**Subject:** Response to Nuclear Regulatory Commission Requests for Additional Information for Relief Request No. RR5-01, Alternate Weld Overlay Repair for a Dissimilar Metal Weld Joining Nozzle to Control Rod Drive End Cap  
Cooper Nuclear Station, Docket No. 50-298, DPR-46

**Response to Nuclear Regulatory Commission Requests for Additional Information for  
10 CFR 50.55a Requests for Fifth Ten-Year Inservice Inspection Interval**

**Cooper Nuclear Station, Docket No. 50-298, DPR-46**

Figure 1

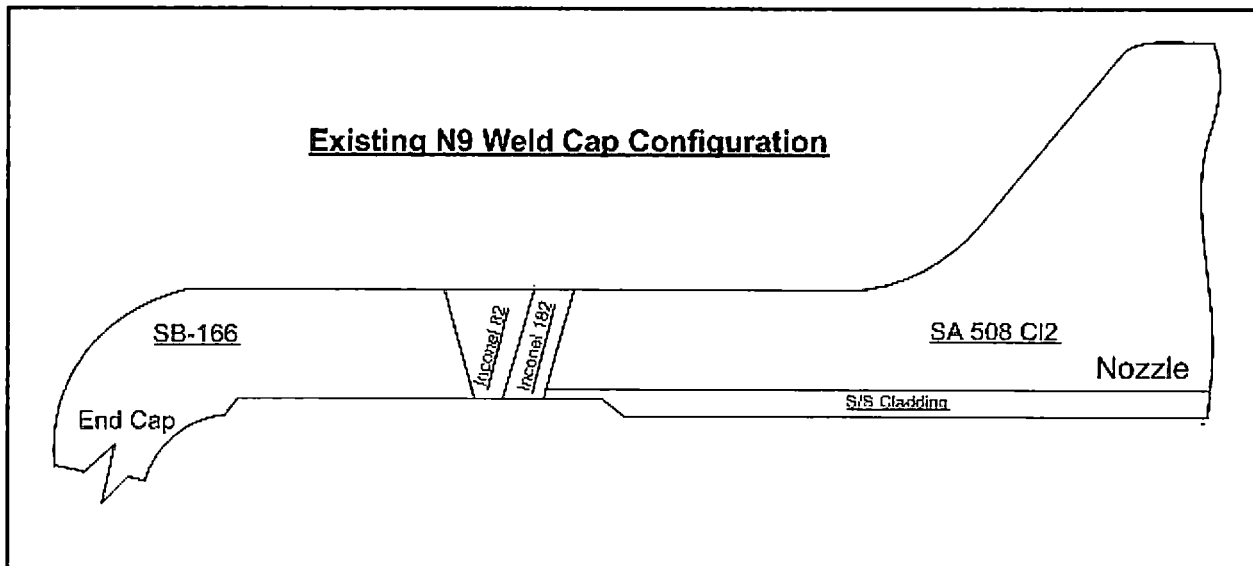
- (a) Identify whether alloy 82 or 182 is used in the final layer of the existing weld joint to which the FSWOL is proposed to be applied.*

- (b) Clarify whether or not austenitic stainless steel material is used in the existing weld joint to which the FSWOL is proposed to be applied. If austenitic stainless steel material is used in the existing weld joint, provide a detailed weld sketch identifying all the following materials: A-508 Class 2, Stainless Steel (specify type), SB-166 Alloy 600, Alloy 82 filler metal, and Alloy 182 filler metal.

- (a) When the cap was installed, the existing 182 open butt weld was cut and machined back to approximately 0.350" remaining at the bevel. CNS installed the cap using a full open butt 82 (ER-NI-CR-3) weld. Stainless steel cladding originally covered the 182 weld but was removed to facilitate fit up of the SB-166 Alloy 600 cap exposing a small portion of the 182 at the inside diameter. See Figure 1.
- (b) As described on page 57 of the Attachment to NLS2015025, the configuration to receive the FSWOL consists of an SA-508, Class 2 low alloy steel nozzle, Alloy 182/82 weld materials, and an SB-166, Alloy 600 cap. There are no stainless steel weld filler materials contained in the weld joint. See Figure 1.
